REGIONAL REVIEW NOTIFICATION

Name of Proposal: Empire Highway 306 DRI 3594 Submitting Local Government: Forsyth County

2022 EMPIRE HIGHWAY 306 DRI Forsyth County Natural Resources Group Comments May 24, 2022

Stream Buffers

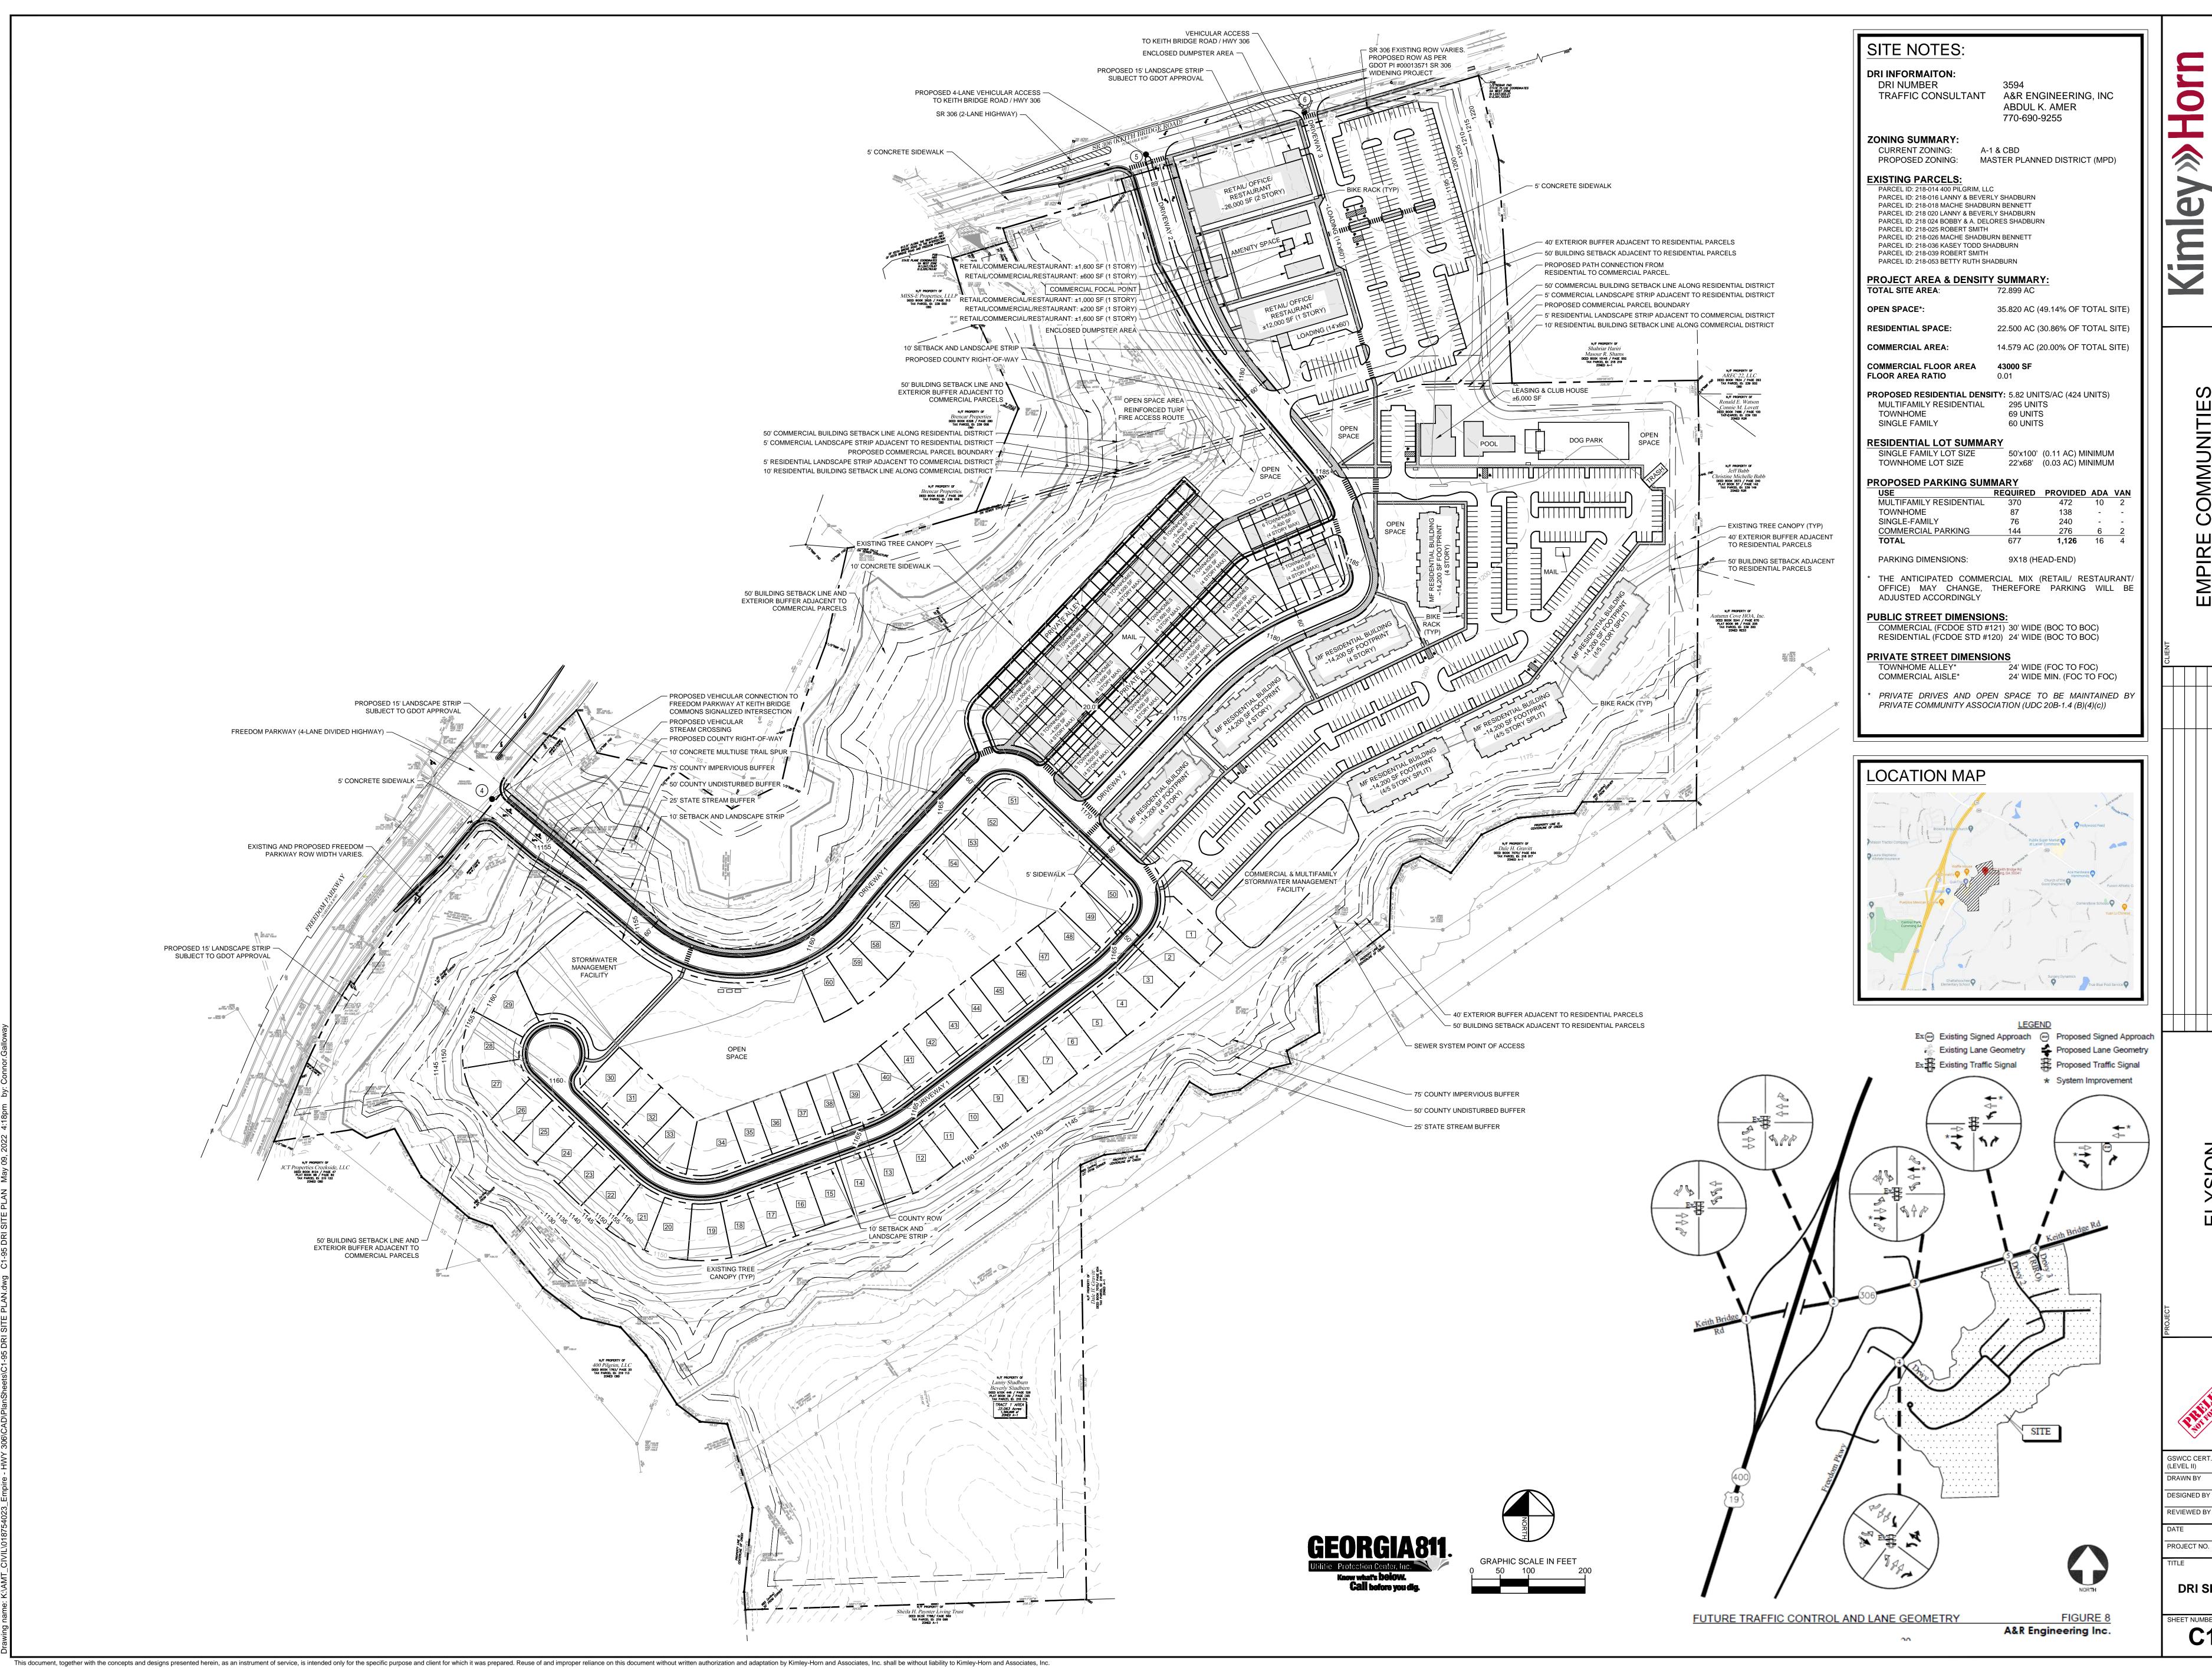
Both the USGS coverage for the project area and the submitted site plan show two streams on the project property. Baldridge Creek runs along the northwestern, western and southwestern sides of the property and a tributary to Baldridge runs along the eastern side of the project property, joining Baldridge Creek near the southern end of the property. The site plan shows the 25-foot State Sediment and Erosion Control buffer as well as the Forsyth County's Stream Buffer Ordinance's 50-foot stream buffer and 75-foot impervious setback along both streams. The only proposed intrusions on the site plans are a stream crossing accessing the property from Freedom Parkway, which is exempt from the buffer standards and the possible intrusion of a proposed 10-foot wide multi-use trail along Driveway 1 a few feet into the 75-foot setback, which may require a variance from the County. Any unmapped streams on the property may also be subject to the City stream buffer ordinance, and all waters of the state on the property are subject to the State 25-foot Sediment and Erosion Control buffer.

DRI SITE PLAN

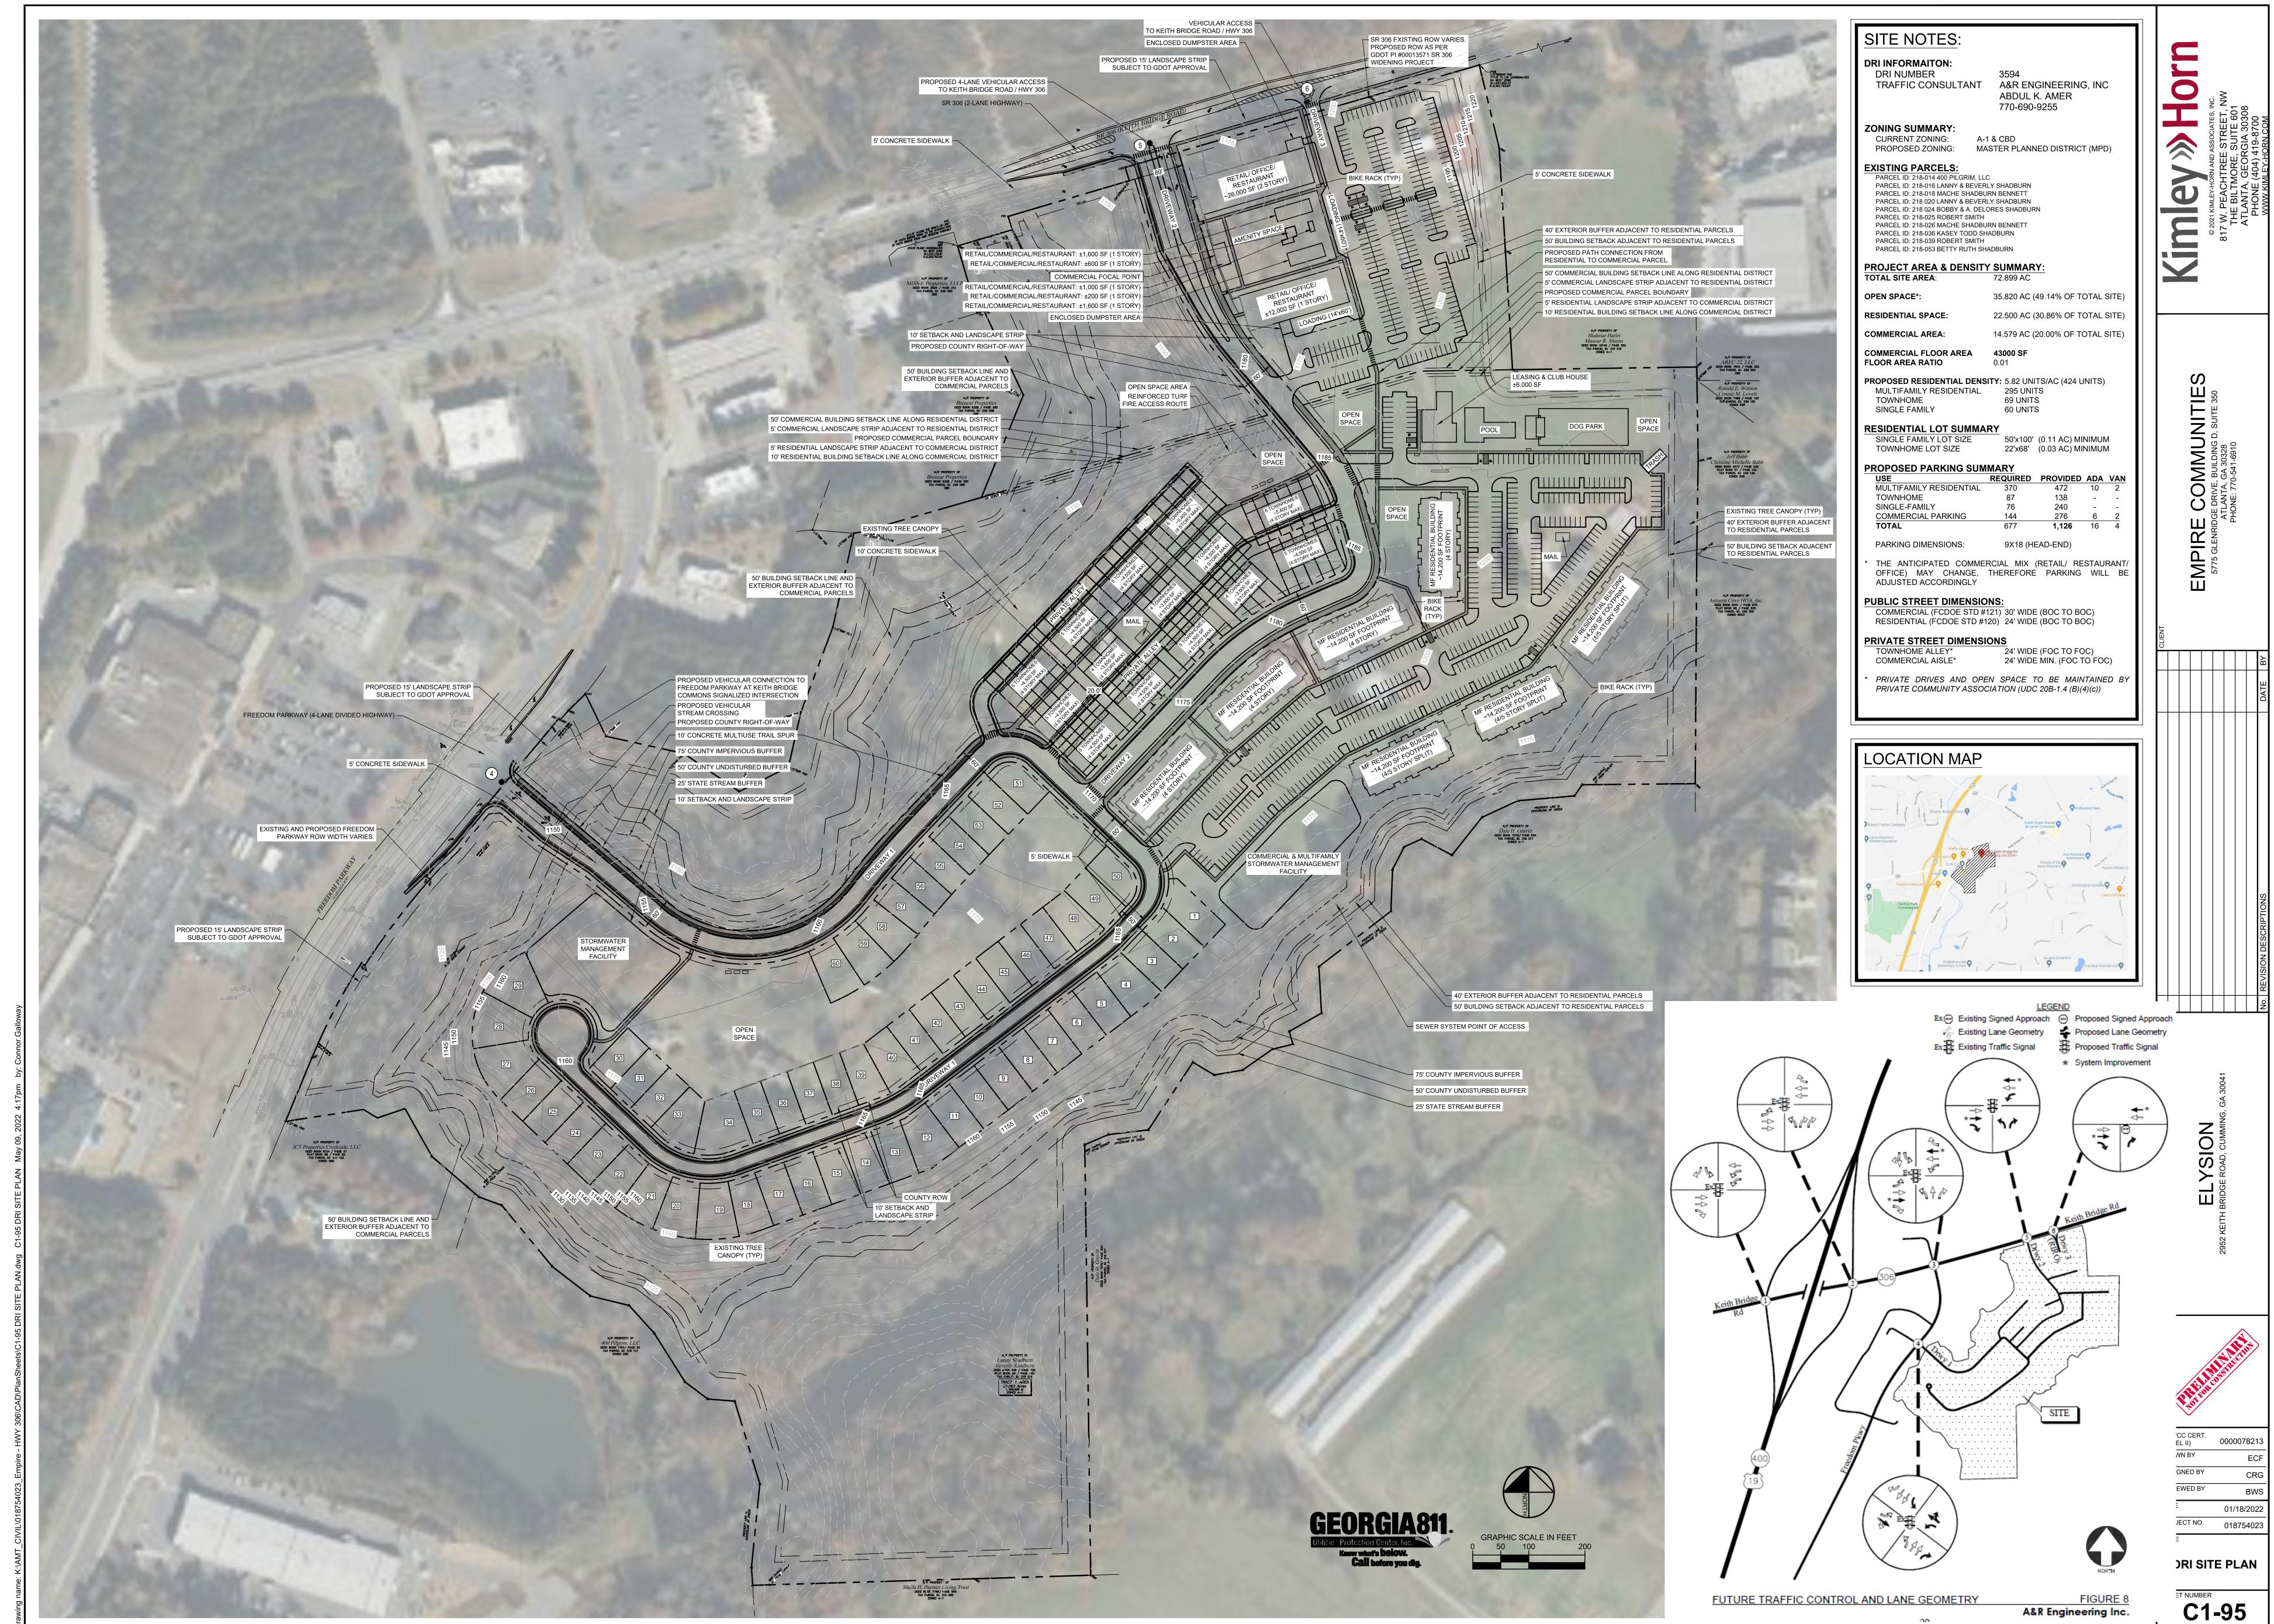
A total of 1,126 parking spaces are provided which is almost double the required number of 677 spaces; no EV charging stations appear to be proposed. A reduction of total spaces to an amount closer to the minimum required and the provision of EV parking spaces would be supportive of regional transportation policies.

Both the USGS coverage for the project area and the submitted site plan show two streams on the project property. Baldridge Creek runs along the northwestern, western and southwestern sides of the property and a tributary to Baldridge runs along the eastern side of the project property, joining Baldridge Creek near the southern end of the property. The site plan shows the 25-foot State Sediment and Erosion Control buffer as well as the Forsyth County's Stream Buffer Ordinance's 50-foot stream buffer and 75-foot impervious setback along both streams. The only proposed intrusions on the site plans are a stream crossing accessing the property from Freedom Parkway, which is exempt from the buffer standards and the possible intrusion

of a proposed 10-foot wide multi-use trail along Driveway 1 a few feet into the 75-foot setback, which may require a variance from the County.

Approximately 36 acres of the site are shown as open space and water quality protection buffer areas. Designation of this area as managed open/conservation space would substantially reduce the overall impact of the project. There may be potential opportunities for linking these fragmented undeveloped areas with adjacent undeveloped or protected areas to ensure their maintenance and potential use for recreation or habitat preservation.
